# FINAL DRAINAGE REPORT FOR CLAREMONT BUSINESS PARK 2 FILING NO. 2 EL PASO COUNTY, COLORADO

**February 2023**

Project #10-020  
PCD Filing No.: VR233

**Basin ID: Lot 2 - Pond 3** (POND 3 TO BE DESIGNED AND CONSTRUCTED WITH THIS REPORT)

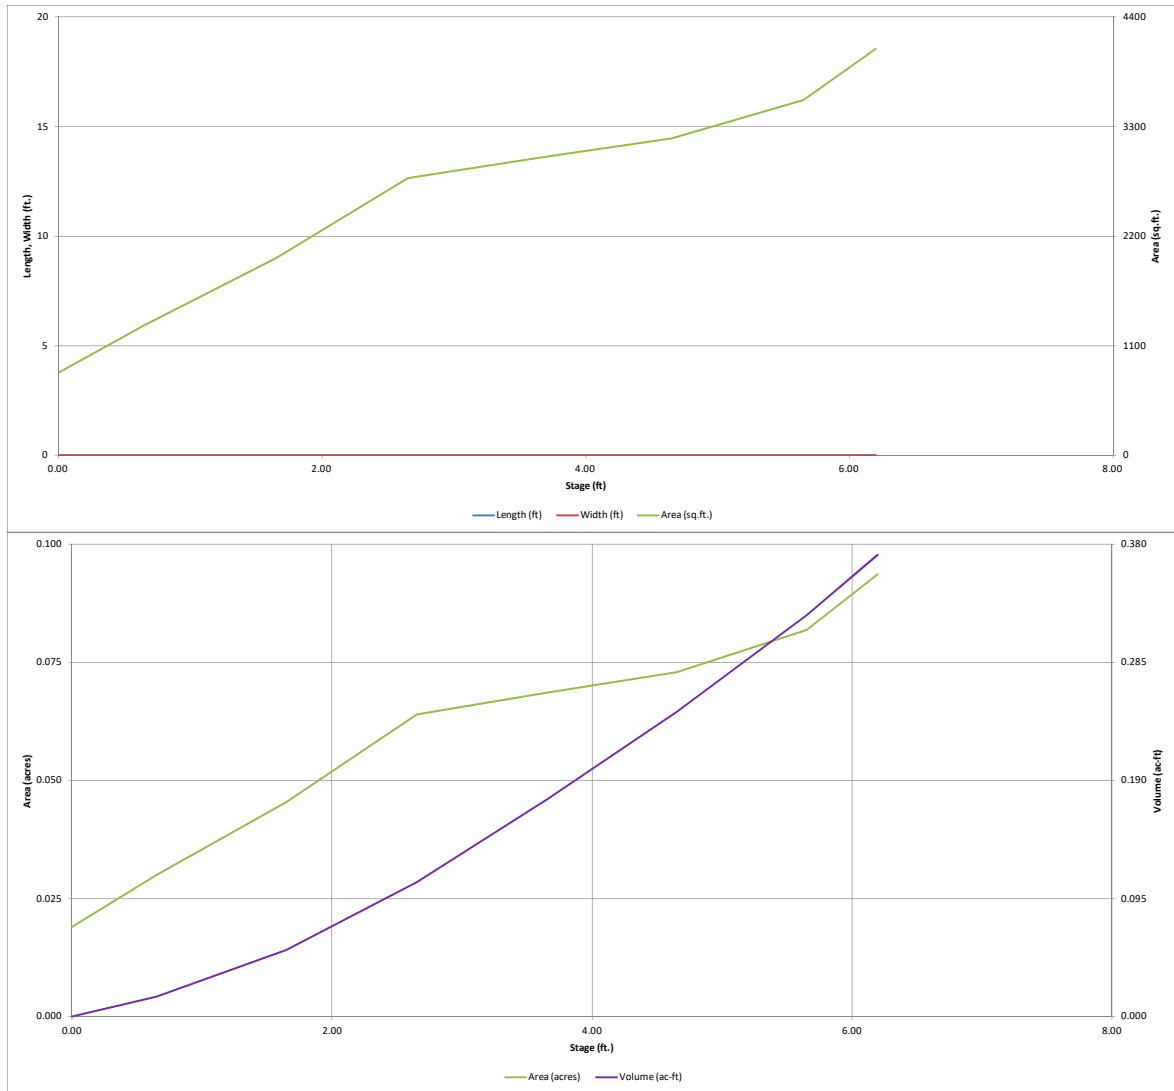
CDs show 4" underdrain. Please revise so both documents show same information
